ADDENDUM NO. 7

Reference: Exhibit Fabrication and Installation – Utah Museum of Natural History
University of Utah
DFCM Project No. 02243750

Subject: **Addendum No. 7**

Utah Museum of Natural History
 Summary Integrated Completion Schedule

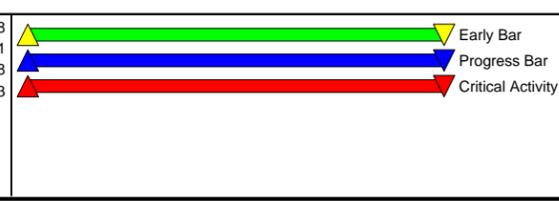
7.2.1 See the attached Summary Integrated Completion Schedule, dated 20 April 2009.
